Appliance Standards Awareness Project
Alliance to Save Energy
American Council for an Energy-Efficient Economy
Consumer Federation of America
National Consumer Law Center, on behalf of its low-income clients
Natural Resources Defense Council

September 19, 2019

RE: Docket Number EERE-2016-BT-TP-0012: Request for Information for Test Procedure for Dishwashers

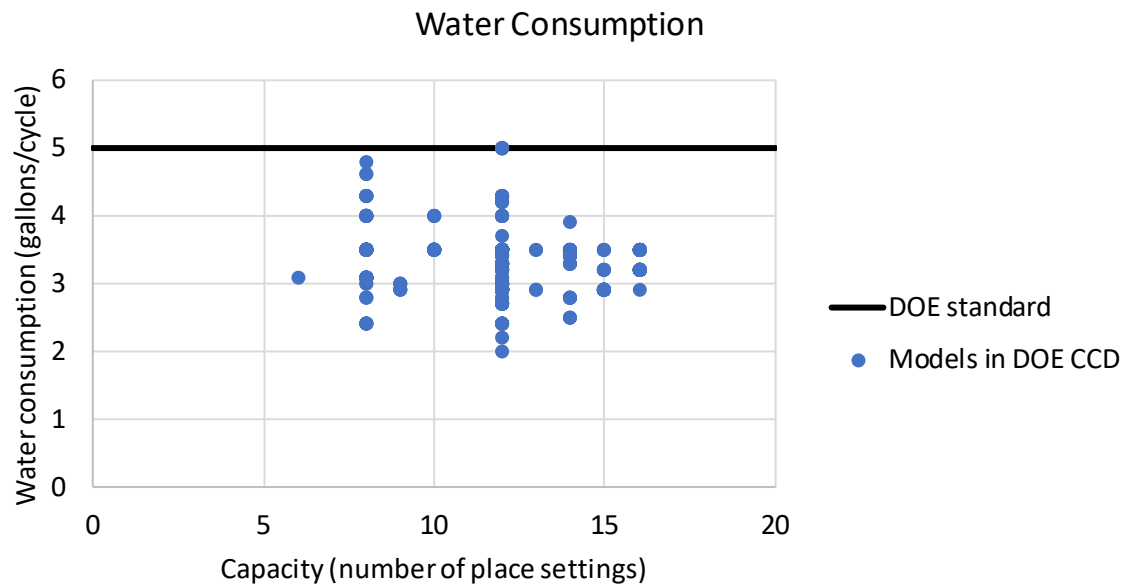
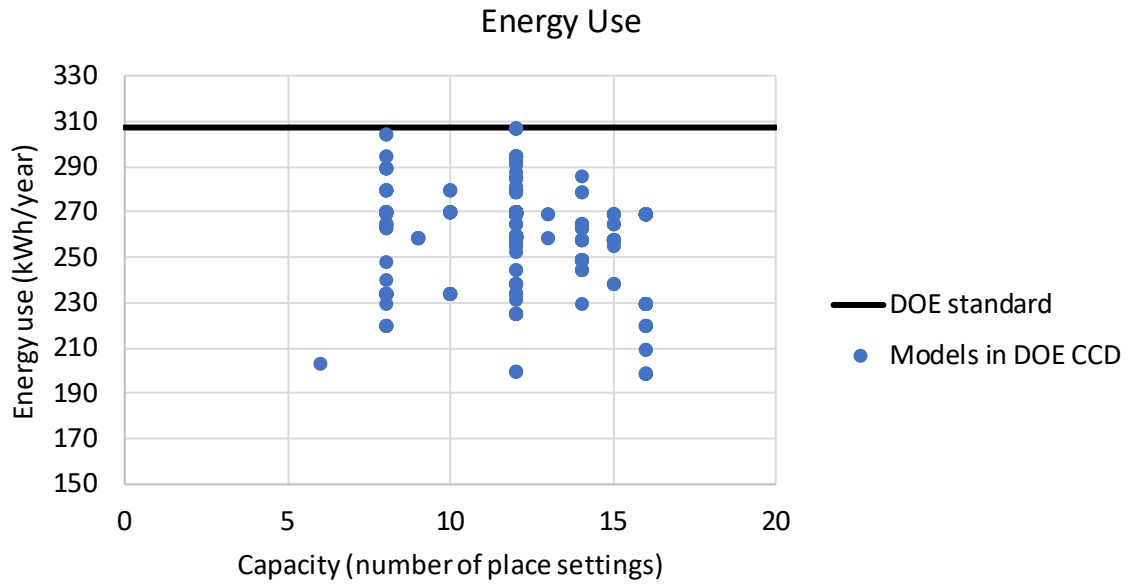
It does not appear that data on current dishwasher models support an approach of establishing energy and water use metrics on a per-place setting basis. The RFI requests comment on a potential approach of establishing energy and water use metrics on a per-place setting basis.⁵ DOE notes that China had commented in response to the December 2014 NOPR suggesting a less stringent standard for larger capacity dishwashers. We would not object to an approach of establishing energy and water use metrics on a per-place setting basis provided there was a sound technical reason to do so. However, data on current dishwasher models do not appear to support the need for such an approach. As shown in the graphs below, based on the energy and water use ratings of current dishwasher models certified to DOE,⁶ there does not appear to be a relationship between dishwasher capacity (number of place settings) and energy or water use. Furthermore, the dishwasher models with the lowest rated energy consumption (199 kWh/year) have the highest capacity of models certified to DOE (16 place settings), and there are dishwashers across the range of capacities that consume significantly less energy and water than what the standards allow.
